**Development:** MOD2022/0211  
224-240 Pitt Street Merrylands. NSW 2160

**Proposal:** Section 4.55(2) Modification of an approved Mixed Use  
development

**Subject:** Request for further information

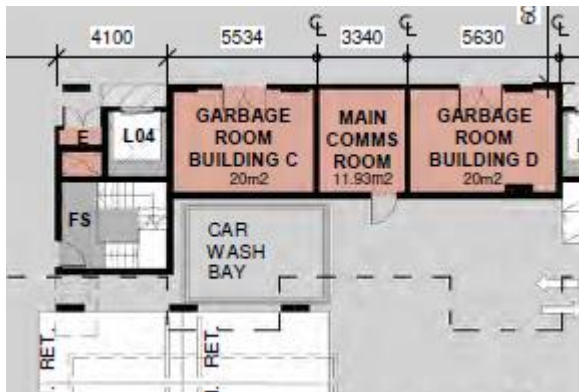
5. *The output results such as water surface levels, ground levels, flood depth, velocity, vxd product in tabular forms are for 5%, AEP, 1%AEP and PMF for pre-development and poste development scenarios for the following locations (refer to the diagram) in addition to that shown on the figure 11 of the Food report, are required for better appreciation of the flooding impacts of the development in the surrounding area.*

This entire section will be addressed by both the Flood and Civil engineer
